Technical Service Bulletin

| SUBJECT: | | No: TSB-18-52B-002 | |
| UPDATES TO SRS AIRBAG DIAGNOSTIC TROUBLE CODE PROCEDURES - SERVICE MANUAL REVISION | | DATE: December 2018 | |
| | | MODEL: 2012 i-MiEV | |

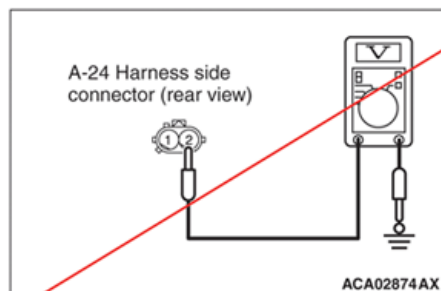
Please make the indicated changes to the 2012 i-MiEV Service Manual, Group 52B - Supplemental Restraint System (SRS) -> SRS Air Bag Diagnosis -> Diagnostic Trouble Code Procedures <SRS-ECU>: Replace the Incorrect information with the Correct information for DTC B1407, Diagnosis.

STEP 3. Check the harness wires for open circuit or short circuit between SRS-ECU connector B-113 (terminal No.18 and 28) and front impact sensor (RH) connector A-24 (terminal No.2 and 1).

NOTE: After inspecting intermediate connector B-28 inspect the wiring harness. If the intermediate connector B-28 is damaged, repair or replace it.

NO : Repair the harness wires between SRS-ECU connector B-113 and front impact sensor (RH) connector A-24. Then go to Step 4.

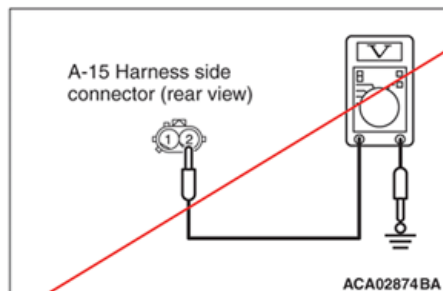
Please make the indicated changes to the 2012 i-MiEV Service Manual, Group 52B - Supplemental Restraint System (SRS) -> SRS Air Bag Diagnosis -> Diagnostic Trouble Code Procedures <SRS-ECU>: Replace the Incorrect information with the Correct information for DTC B1417, Diagnosis.

STEP 3. Check the harness wires for open circuit and short circuit between SRS-ECU connector B-113 (terminal No.17 and 27) and front impact sensor (LH) connector A-15 (terminal No.2 and 1).

NOTE: After inspecting intermediate connector B-28 inspect the wiring harness. If the intermediate connector B-28 is damaged, repair or replace it.

NO : Repair the harness wires between SRS-ECU connector B-113 and front impact sensor (LH) connector A-15. Then go to Step 4.

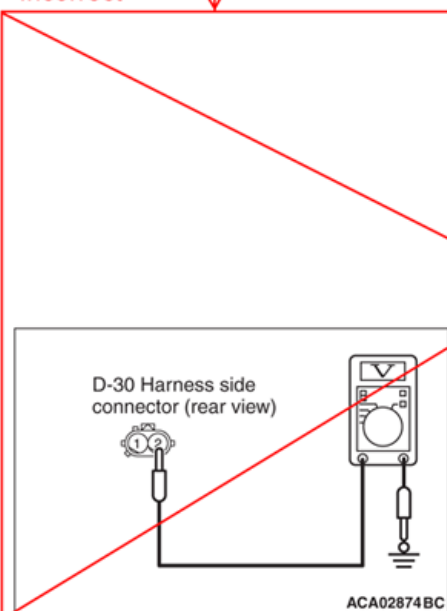
Please make the indicated changes to the 2012 i-MiEV Service Manual, Group 52B - Supplemental Restraint System (SRS) -> SRS Air Bag Diagnosis -> Diagnostic Trouble Code Procedures <SRS-ECU>: Replace the Incorrect information with the Correct information for DTC B1427, Diagnosis.

STEP 3. Check the harness wires for open circuit or short circuit between SRS-ECU connector B-111 (terminal No.64 and 65) and side impact sensor (RH) connector C-30 (terminal No.1 and 2).

NO : Repair the harness wires between SRS-ECU connector B-111 and side impact sensor (RH) connector C-30. Then go to Step 4.

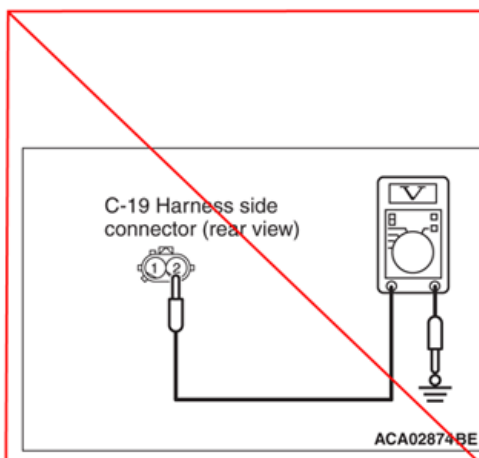
Please make the indicated changes to the 2012 i-MiEV Service Manual, Group 52B - Supplemental Restraint System (SRS) -> SRS Air Bag Diagnosis -> Diagnostic Trouble Code Procedures <SRS-ECU>: Replace the Incorrect information with the Correct information for DTC B1437, Diagnosis.

Q: Is the check result normal?

NO : Repair the harness wires between SRS-ECU connector B-112 and side impact sensor (LH) connector C-19. Then go to Step 4.
